AFFIDAVIT OF ROBERT FITZPATRICK
AND SUPPORTING DOCUMENTS

II.E.3.1 Emergency Power Supply for Pressurizer Heaters

II.E.3.1 PGandE Response

Fig. II.E.3.1-2

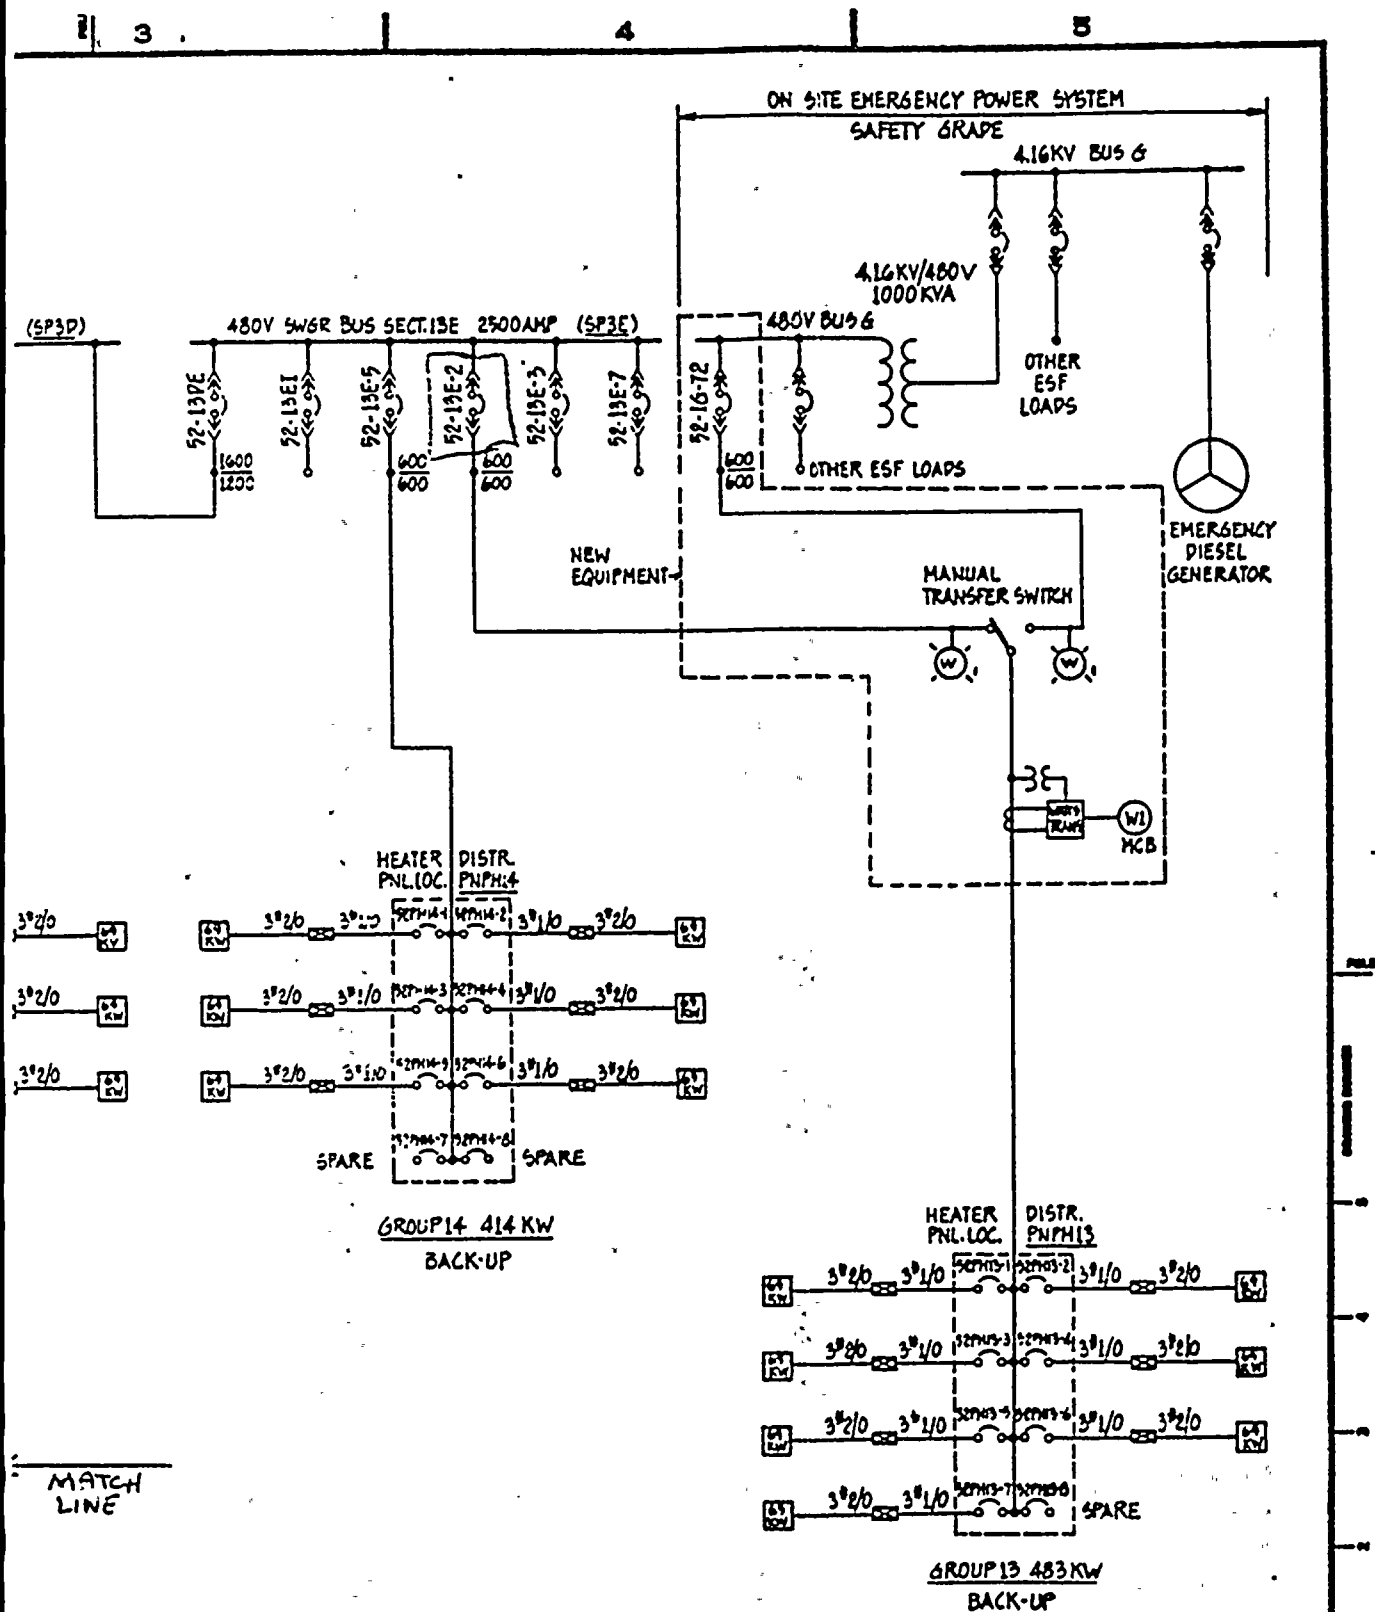
Circuit breakers 52-G-72 and 52-1H-74 have been added to 480 volt ESF buses 1G and 1H, respectively (see Figure II.E.1-2). These breakers have been installed and are seismically qualified to meet safety-grade requirements. The seismic qualification is based on PGandE's testing experience on similar equipment which has previously demonstrated that electromechanical equipment can withstand numerous high seismic events without damage, and that the equipment will be available to perform its safety function when called upon after the seismic event.

Fig. II.E.3.1-3

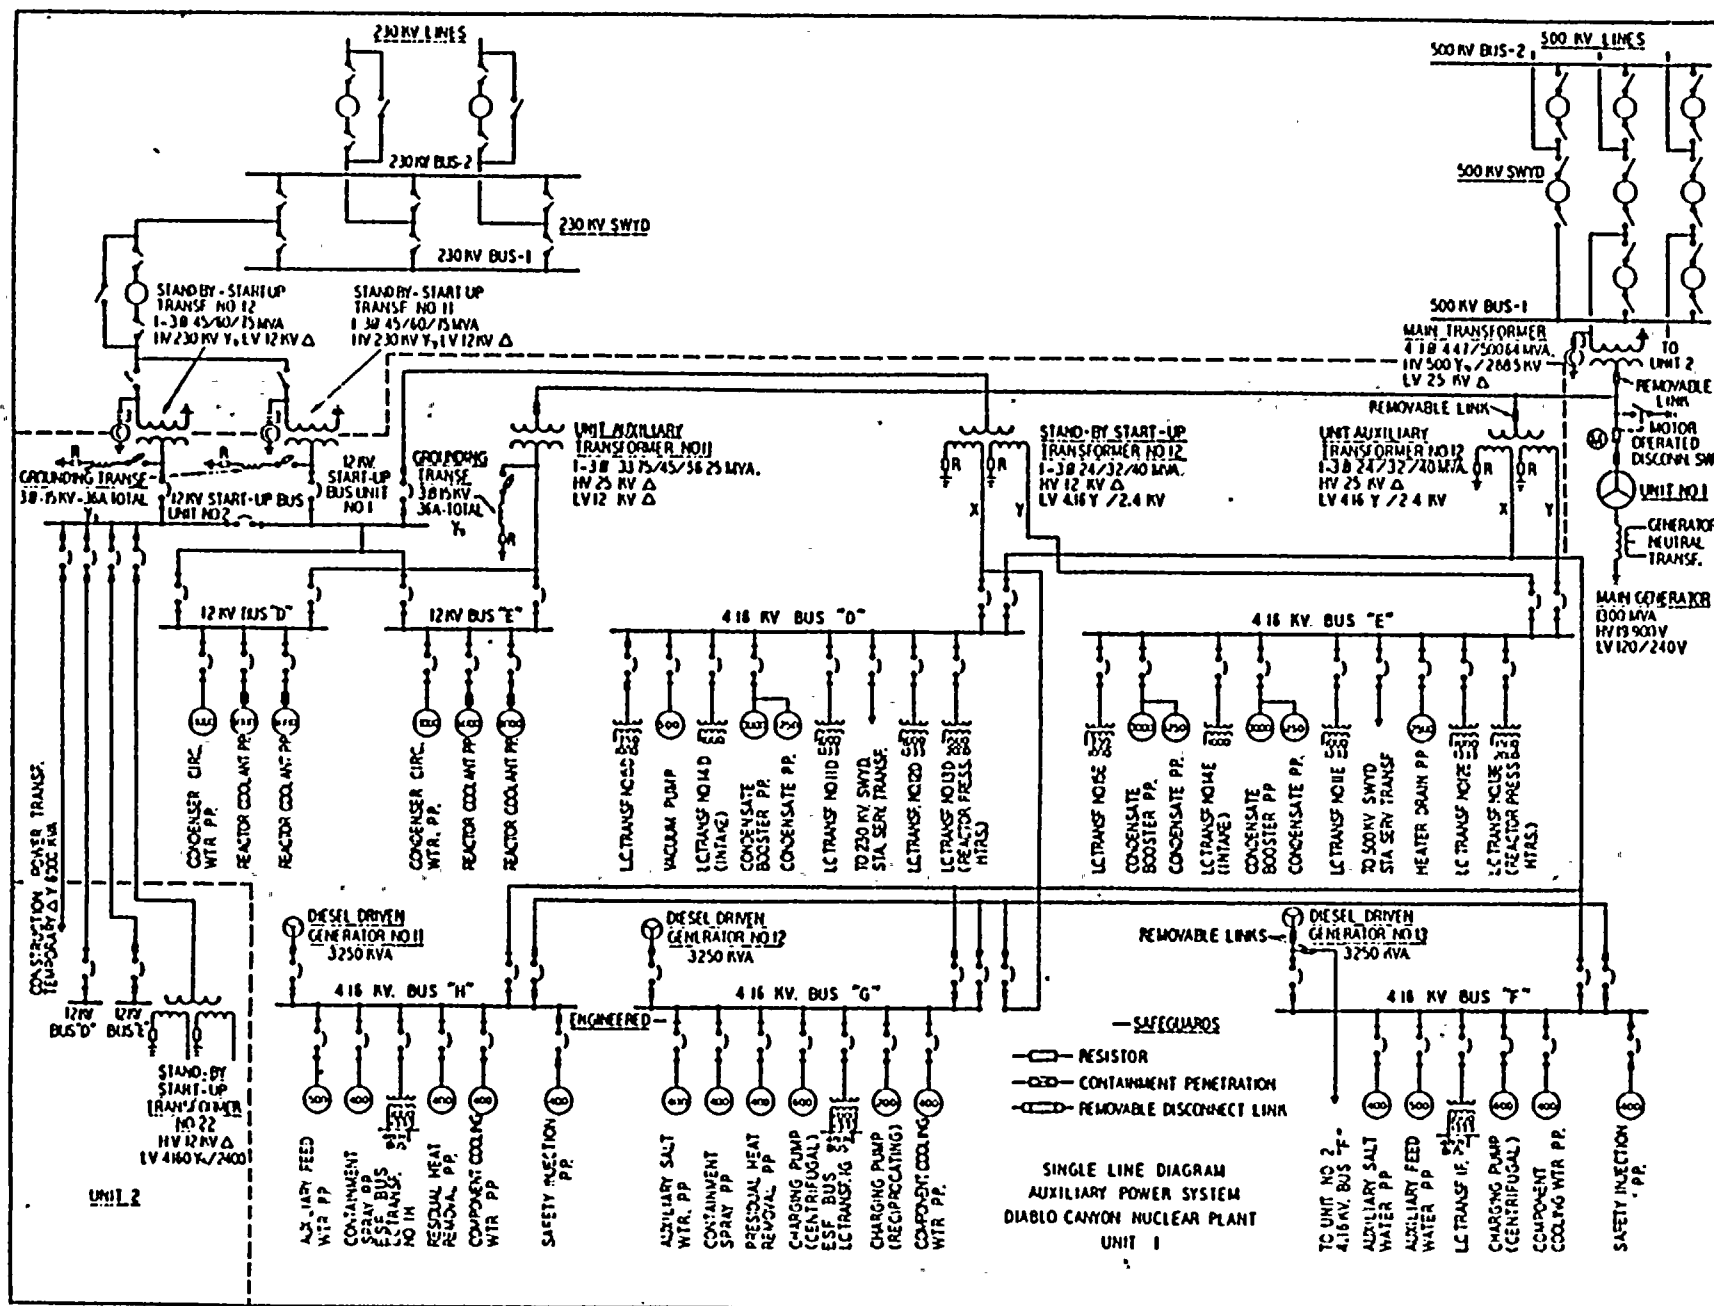
The design (see Figures II.E.3.1-3 and II.E.3.1-4) provides for simple and rapid transfer of the heater groups to the ESF power source. The procedure for transfer of the heater groups to the ESF power source is described briefly below.

When it is determined that the pressurizer heaters are required, the Shift Foreman needs only to dispatch an operator to the 100 foot elevation in the Auxiliary Building, which is just three floors directly below the main control room (two separate stairwells are available). Once in the area, the operator simply verifies that the source breakers (52-1H-74, 52-13D-6, 52-13E-2, 52-1G-72) are open (white "Power on" lights indicate if either source is energized), and manually throws the deenergized transfer switches. This action in itself will not connect the pressurizer heaters onto the ESF buses. Only when the Shift Foreman is informed that the transfers have been made, will the heaters again be controlled using the normal control devices provided on the main control console (see Figure II.E.3.1-1). Even with manual transfer, the heaters can be supplied with emergency power well within the one hour limit recommended by Westinghouse. PGandE will provide control room indication of actual wattage being supplied to each heater group that has been transferred to the emergency power sources. Diesel generator loading parameters are also displayed in the control room.
